Product Change Notification

PCN Plastic Screw Nut Harmonisation

D10-032-450

Old screw nut dimension and appearance	New screw nut dimension and appearance
<p>Mounting diameter M16:</p> 	<p>Mounting diameter M16:</p>

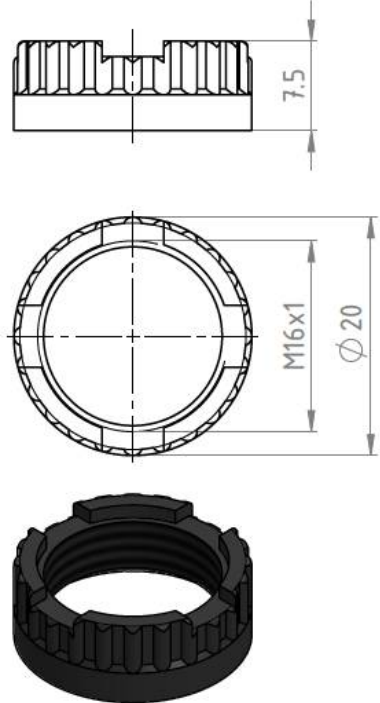
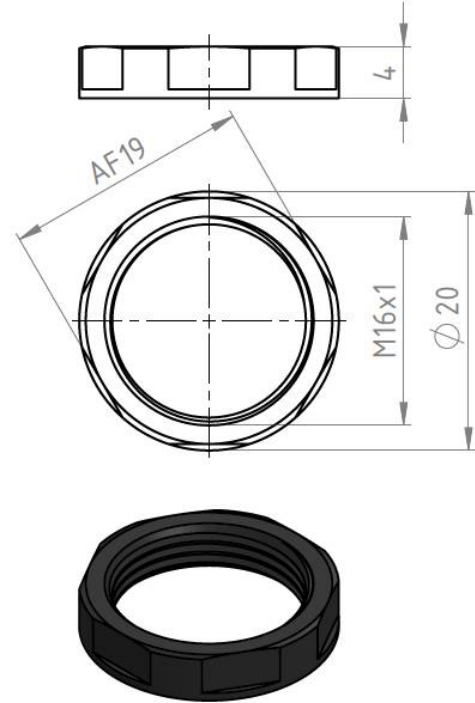
- Change of the plastic screw nut for mounting
